Updated Acoustic Comment and Advice Proposed Preschool & Community School – 1 Rosemead Road, Hornsby, NSW

The most recent update of my acoustic assessment report in relation to the new Blue Gum Preschool & Community School proposed for 1 Rosemead Road, Hornsby, NSW is presented in the document:

Acoustic Assessment Report: Proposed Preschool & Community School – 1 Rosemead Road, Hornsby, NSW (NG Child & Associates; Version 5; May 6th, 2020.

Attachment 1 – Proposal as Lodged

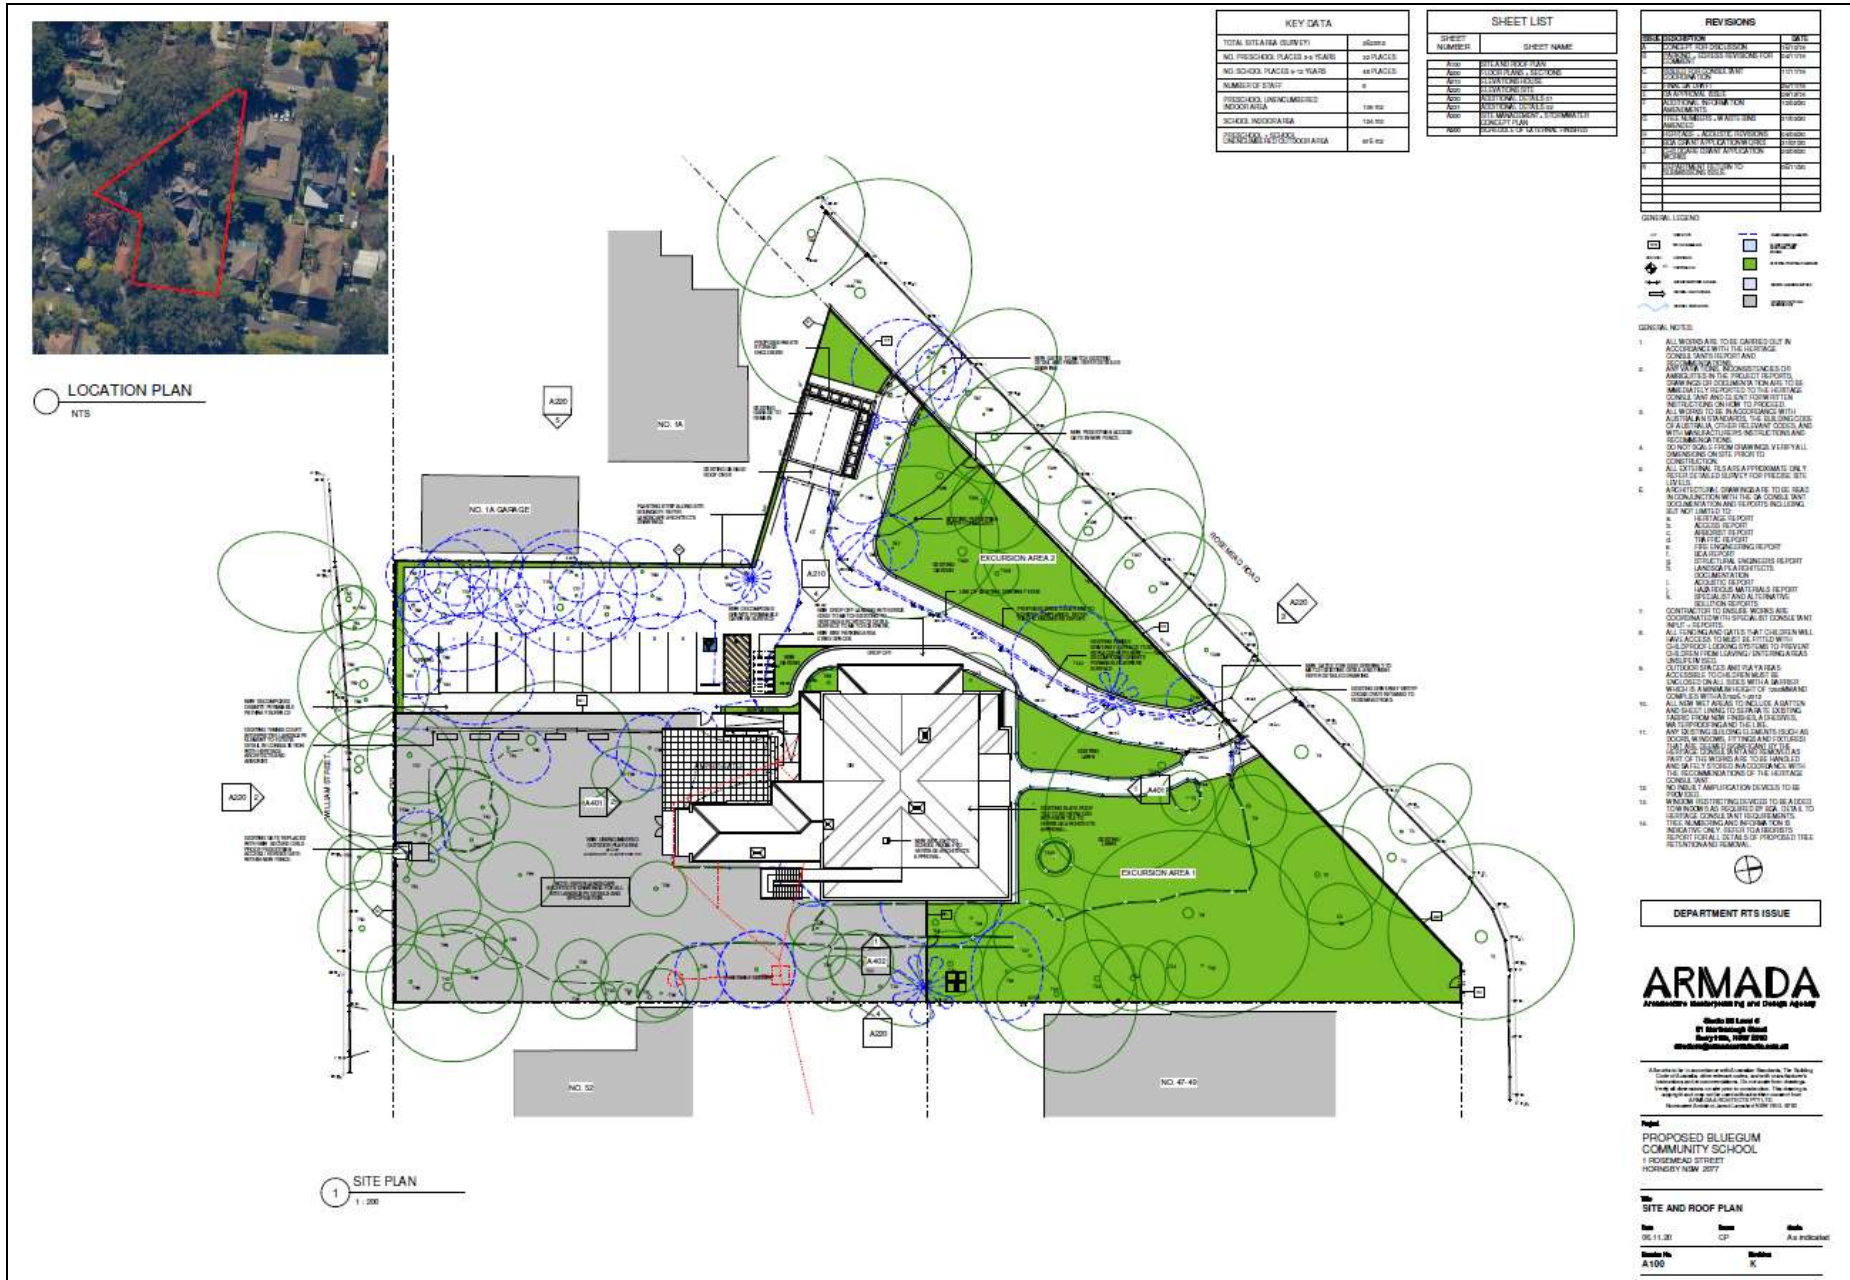
The original and modified proposals are summarised in Attachments 1 and 2, respectively.

Version 5 of my acoustic report involved an increase in the recommended height of the acoustic fence proposed for the boundary between the car park area and the adjacent residential property at 1A Rosemead Road from 1800 mm to 2100 mm.

Version 5 of my acoustic report included an 1800 mm high double lapped and capped timber acoustic fence along the south-western boundary fence section between the development site and the adjoining property at 1A Rosemead Road, which is the fence section between the car park area and the front or Rosemead Road boundary.

Version 5 of my acoustic report included an 1800 mm high double lapped and capped timber acoustic fence along the southern or William Street property boundary. What is proposed is the replacement of this timber acoustic fence with some other form of more open style fencing. This property boundary adjoins a roadway (William Street) and is separated from potentially affected residential receivers by that roadway. On this basis, an acoustic fence is not strictly required on this property boundary, and in my opinion the more open style non-acoustic fence now proposed involves no risk of undue or non-compliant acoustic impacts on any nearby residential or other property.
